GROUP FUE	MODEL 2014-2018MY Soul (PS) 2012-2017MY Rio (UB) 2014-2017MY Forte (YD, YDm)
	NUMBER 038	DATE April 2018
TECHNICAL SERVICE BULLETIN		
SUBJECT: CANISTER CLOSE VALVE INSPECTION AND AIR DRAIN CASE REPLACEMENT

CCV INSPECTION AND AIR DRAIN CASE REPLACEMENT

Air Drain Case
(YD & YDm)

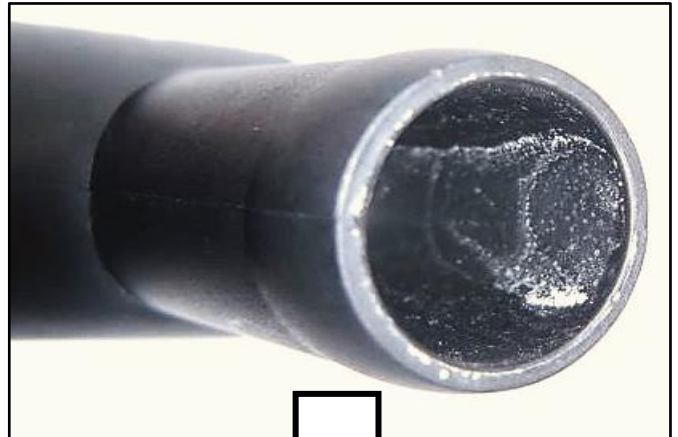
This bulletin provides the procedure to inspect and if necessary, replace the Air Drain Case on some 2014-18MY Soul (PS), produced from July 21, 2013 through June 1, 2017, some 2012-2017MY Rio (UB), produced from June 21, 2011 through March 31, 2017, some 2014-2017MY Forte (YD) vehicles, produced from February 18, 2013 through March 2, 2017, and some 2017MY Forte (YDm) vehicles, produced from May 16, 2016 through March 6, 2017, which may experience an early shut-off during fuel refill and/or a malfunction indicator lamp (MIL) illumination with DTC(s) P0449 or P0451. Follow the procedure outlined in this bulletin to inspect and if necessary, replace the Air Drain Case.

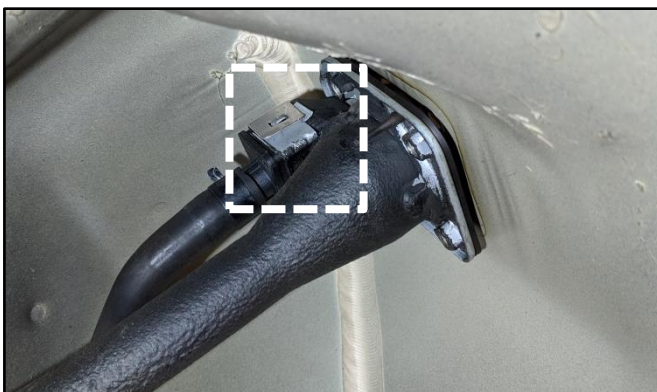
- 5a. **Forte (YD) and (YDm):** Install the new improved fuel filler neck air drain case in the reverse order of removal. Ensure the vent of the Air Drain Case (J) is inserted properly through the opening (K) and ensure a click is heard when installing the new air drain case assembly.

Ensure the outer air drain case half is installed in the correct orientation with the contacts aligned and not upside down.

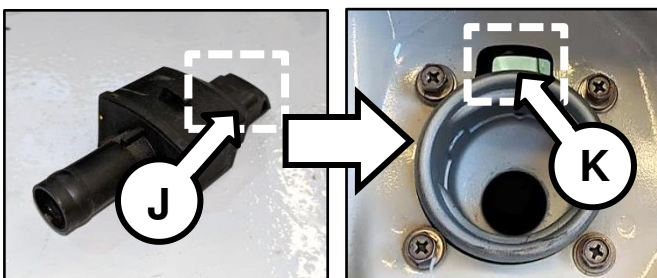
- 5b. **Soul (PS) and Rio (UB):** Install the new improved fuel filler neck Air Drain Case in the same reverse order of removal. Ensure the vent of the Air Drain Case (J) is inserted properly through the opening (K) and ensure a click is heard when installing the retaining bracket.

6. Tighten the four (4) fuel neck filler retaining bolts (B) to specifications from step 2.

Tightening torque for bolts (B):
 69.03 – 104.43 lb.in (7.8 – 11.8 N.m,
 0.8 – 1.2 kgf.m).
